Hydrol. Earth Syst. Sci. Discuss., author comment AC1  
<https://doi.org/10.5194/hess-2021-5-AC1>, 2021  
© Author(s) 2021. This work is distributed under  
the Creative Commons Attribution 4.0 License.

## Reply on RC1

Author comment on "Drought-induced non-stationarity in the rainfall-runoff relationship invalidates the role of control catchment at the Red Hill paired-catchment experimental site" by Yunfan Zhang et al., Hydrol. Earth Syst. Sci. Discuss.,  
<https://doi.org/10.5194/hess-2021-5-AC1>, 2021

### Response to Reviewer #1

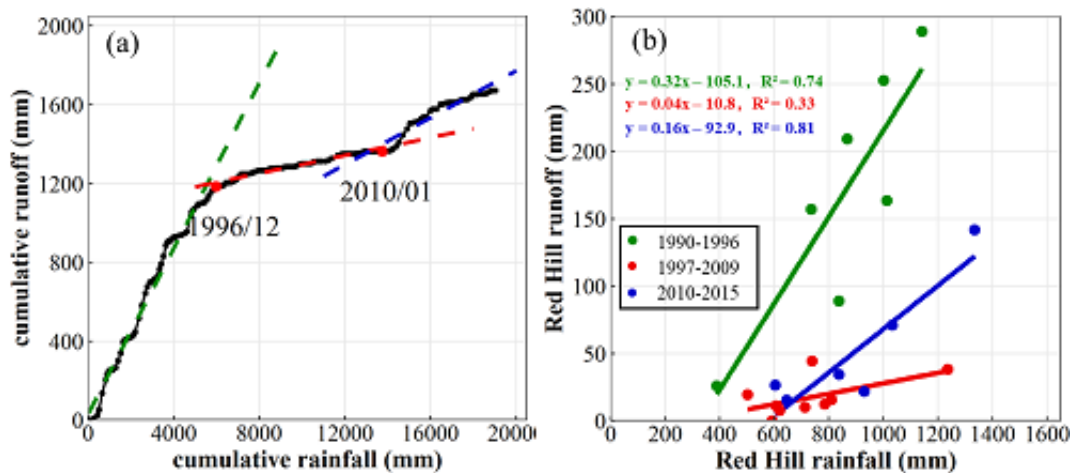
- It's a flaw that the manuscript lacked detection of changes in the rainfall-runoff relationship for the treated catchment. Although it's obvious why there is a control and a treated catchment, I think it's important to apply the appropriate parts of the applied analysis for the treated catchment, also to have a better understanding of the underlying processes; to confirm or to deny the non-linear behaviour of the treated catchment.

A. If the treated catchment has not been reforested, did you expect the treated catchment to show similar behaviour as the control catchment?

B. Does the treated catchment already shows the same non-linearity as the control catchment?

A. If the treated catchment has not been reforested, we expect the treated catchment to show similar behaviour as the control catchment. Because the terrain, meteorology, area of the two catchments are very similar, when the treated catchment is not reforested, the land cover types of the two catchments are also similar, both are grassland. When prolonged drought occurs, the change of hydrological process in two catchments should be similar.

B. Yes, the treated catchment shows the similar non-linearity as the control catchment, as shown in Figure R1 and Figure 5 (Page 39). But observed changes in treated catchment should be driven by two factors, i.e. afforestation and prolonged drought by assuming prolonged drought can lead to changes in rainfall-runoff relationship of the treated catchment.

Figure R2 The variation in monthly rainfall of the Kileys Run catchment (control catchment), New South Wales, Australia, during the periods of 1990–2015.

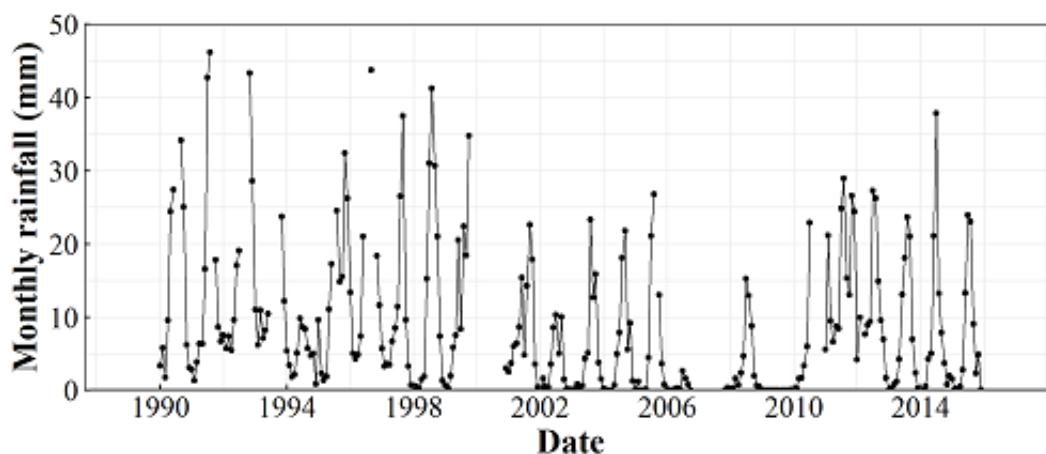
- Lines 139-147; what is the variation in monthly rainfall? Seasonal? What Köppen climate?

The variation in monthly rainfall can be seen in Figure R2. Seasonal changes in monthly rainfall can be seen in Figure R3. The monthly rainfall decreased great during the period of 2001-2009 and increased after 2010, but is still less than the monthly rainfall before 2001. There is more precipitation in winter (June, July and August), but the difference amongst rainfall of four seasons is small. The climate type in Kileys Run and Red Hill catchment is Cfb (temperate maritime climate) (Peel et al., 2007).

Figure R4. (a) Monthly runoff at control (Kileys Run) vs. treated (Red Hill) catchments in New South Wales, Australia, during the calibration period, and (b) Monthly rainfall vs. runoff of the treated catchment during the calibration period. Dashed line is the 1:1 line.

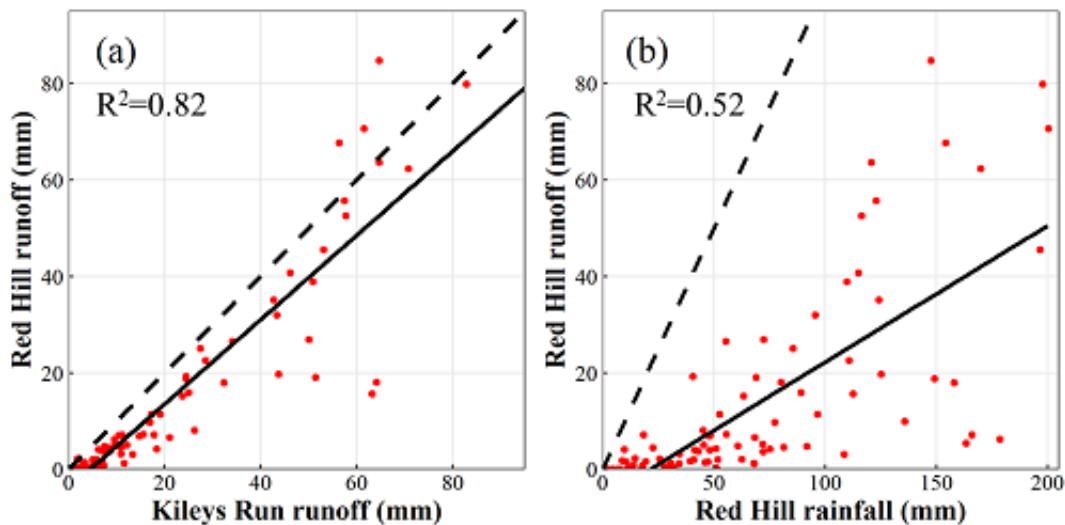
- Figure 4. A. The left figure is Kileys Run, but in the caption you mention Red Hill first, change either the caption or the figure order. B. The x- and y-axis do have different ranges, this makes the graphs difficult to compare and to understand the meaning of the results.

Reply: Thanks for your helpful suggestions. Figure 4 will be replaced by Figure R4 in revised manuscript as follows:

A. The title of Figure 4 has been changed to that of Figure R4.

B. The runoff-runoff relationship for the two paired catchments in Figure 4 (a) is used in the paired catchment method, and the rainfall-runoff relationship of the treated catchment in Figure 4 (b) is used in the time-trend analysis method.

Figure R5. Daily flow duration curves of the Kileys Run catchment (i.e., control catchment), New South Wales, Australia, over four different periods (see legend).

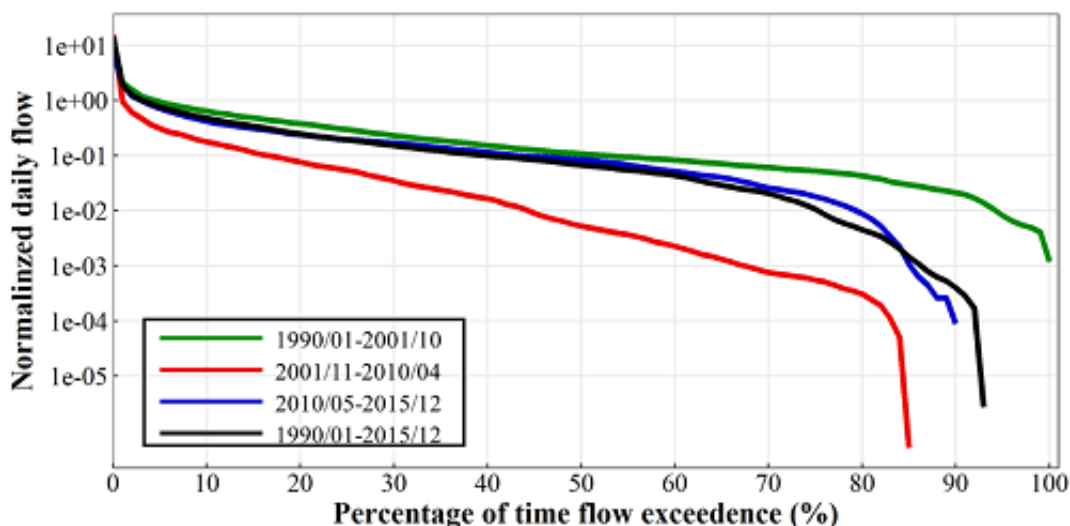
- Figure 6; you may consider add the daily flow duration curve for the entire measurement period (1990-2015) to indicate the differences;

Reply: Thanks for your helpful suggestions. The daily flow duration curve including the entire measurement period (1990-2015) can be seen in Figure R5.

The FDC of the entire measurement period (1990-2015) is close to the FDC of the third

period (2010-2015). There is 6% no-flow days during the whole period. In the first period (pre-drought), the second period (after drought) and the whole period (including the whole drought period), high flows have a highly consistent change, but the difference amongst low flows is significant. It indicates that the impact of prolonged drought on the low flow is more serious than that of the high flow. When the rainfall increases, the high flow may recover quickly, but the low flow may recover slowly.

Figure R6. Estimated monthly values of parameters (a)  $C$  and (b)  $SC$  used in the two-parameter monthly water balance model for the Kileys Run catchment (control catchment), New South Wales, Australia, during the period of 1990–2015.

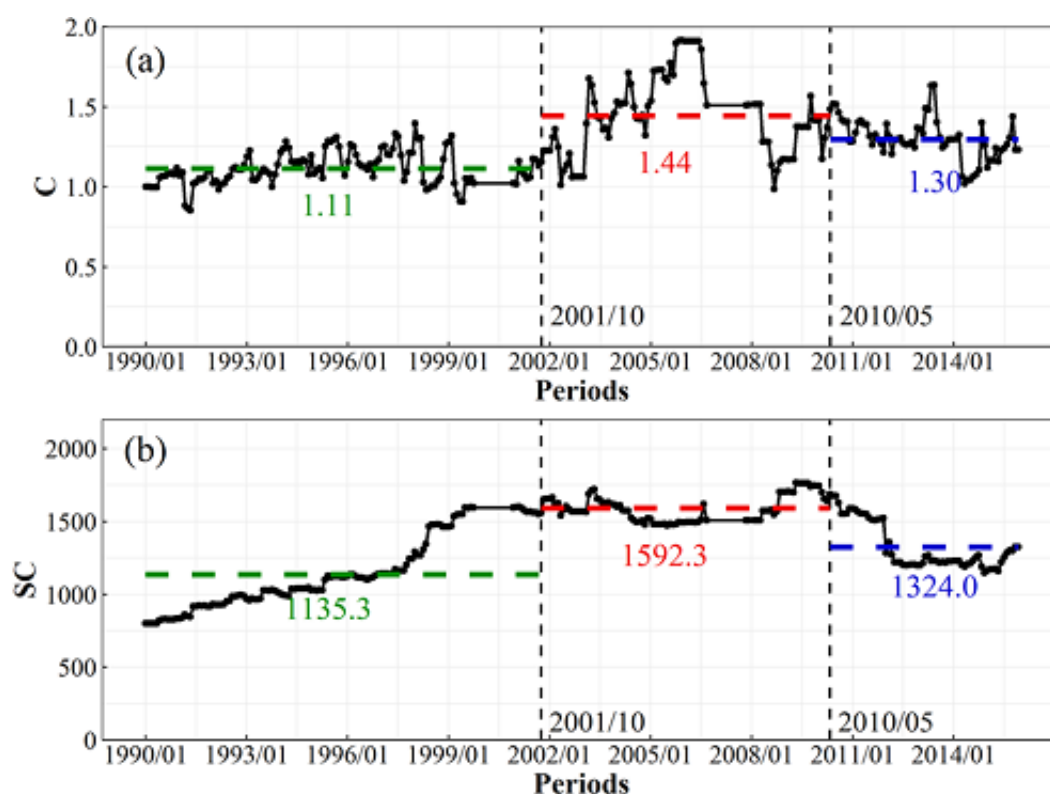
- Figure 7; The x-axis of the graphs could be better aligned;

Reply: Thanks for your helpful suggestions. Figure 7 will be replaced by Figure R6.
